**Devil's Slide
Final Second Supplement to the 1986
Environmental Impact Statement/Environmental Impact Report**

**Route 1 from the Half Moon Bay Airport to Linda Mar Boulevard,
Pacifica, San Mateo County, California**

**VOLUME 2
Comments and Responses**

MAY 2002

EXHIBIT D

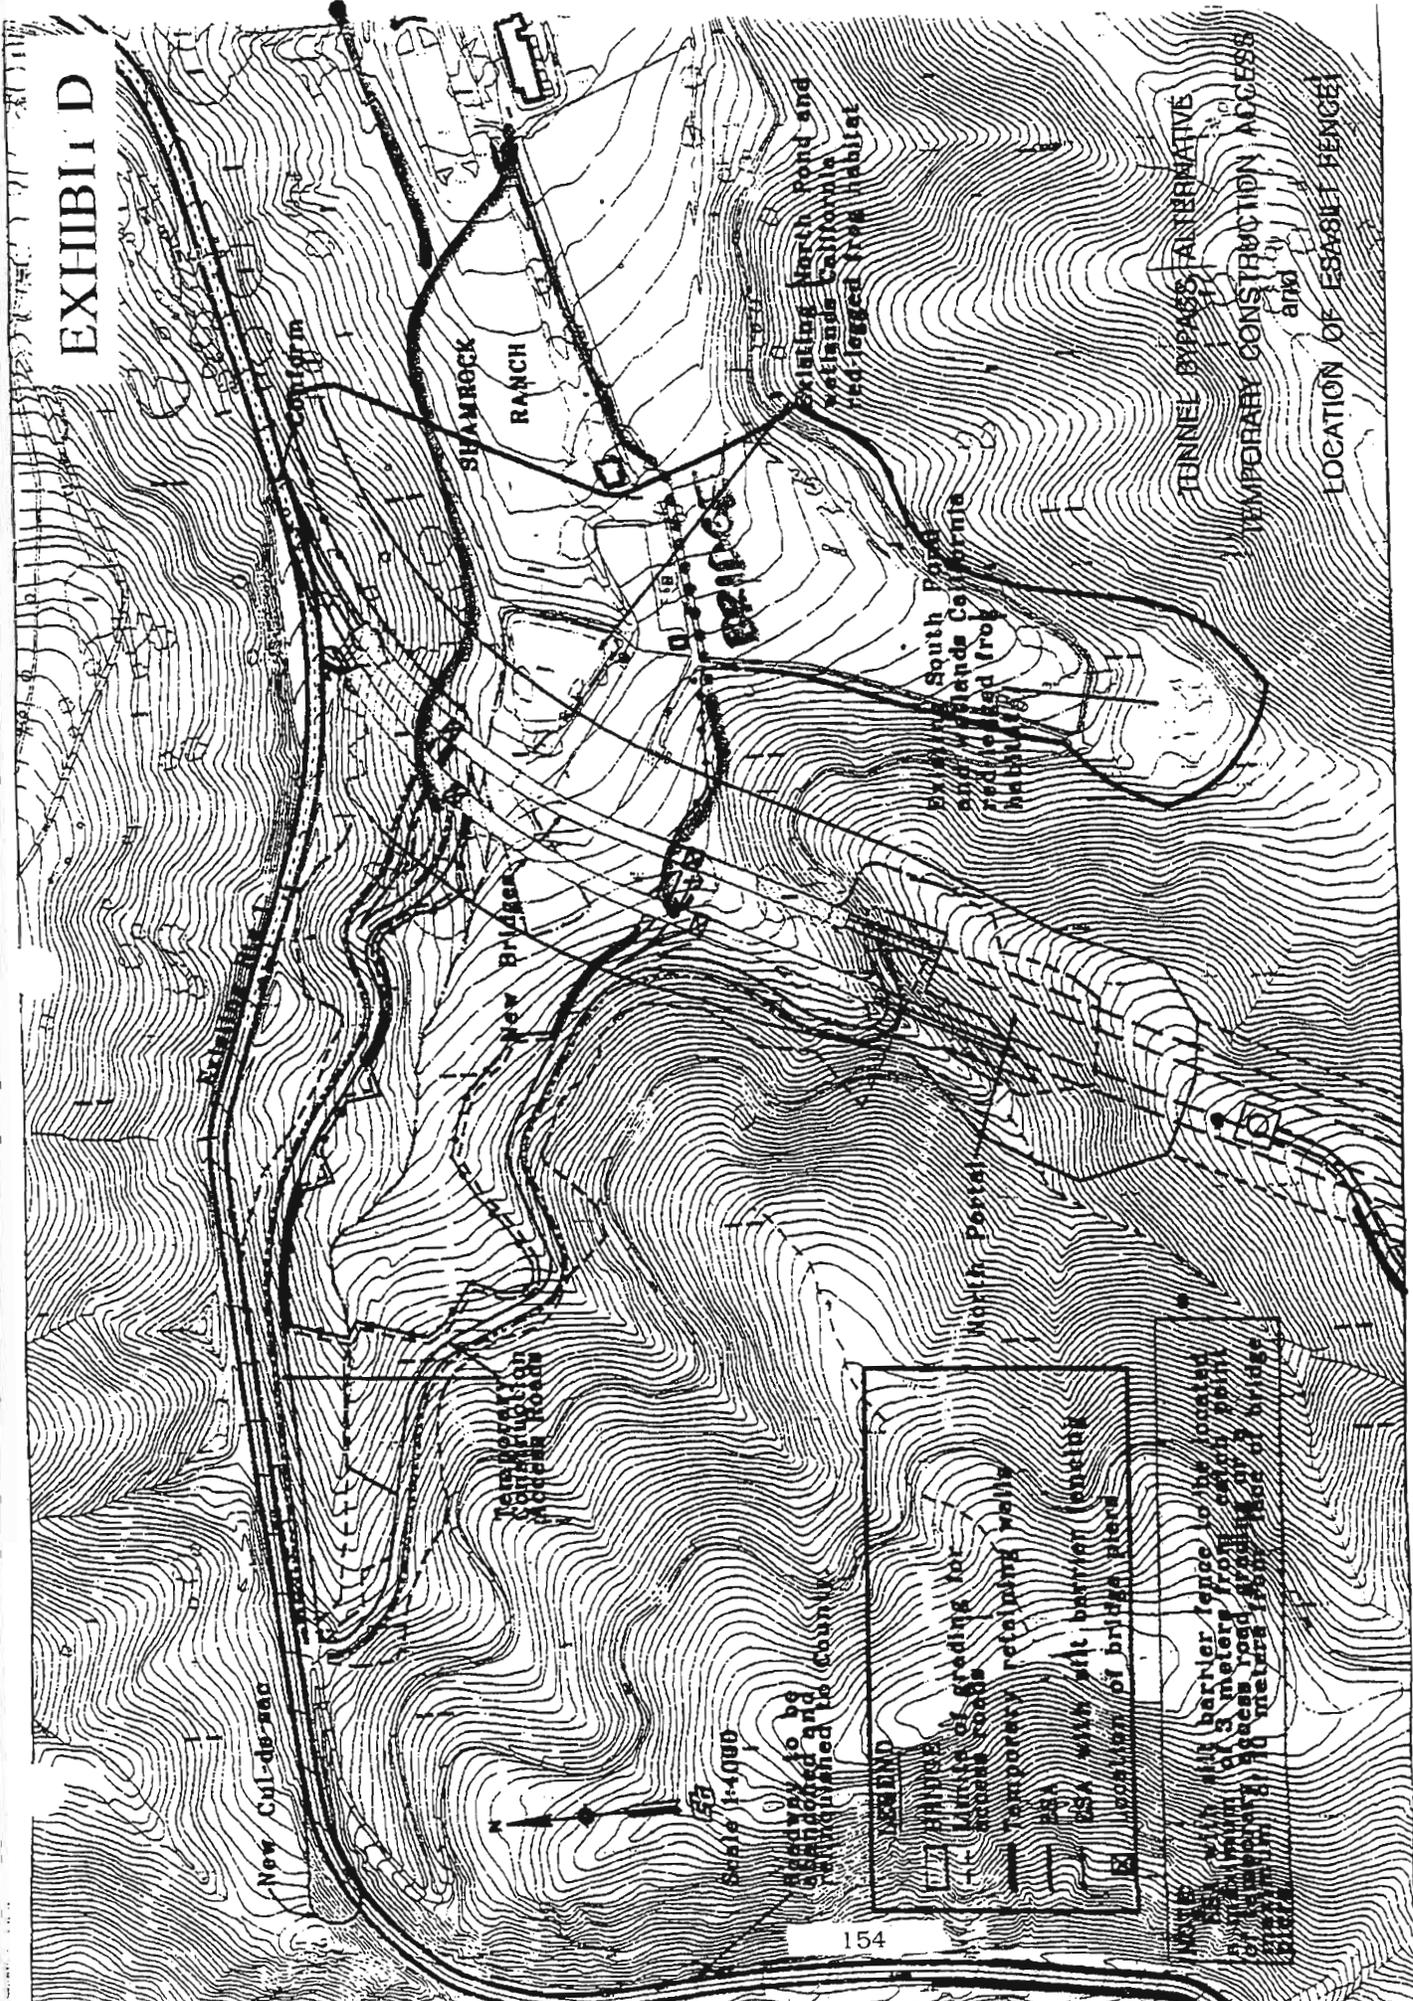
Attachment: Map Exhibit D with drawn in *Shamrock Ranch Temporary Construction Road Access Alternative*
 Caltrans 5/12/99 Estimate of the Proposed Highway-1 Temporary Construction Access Roads
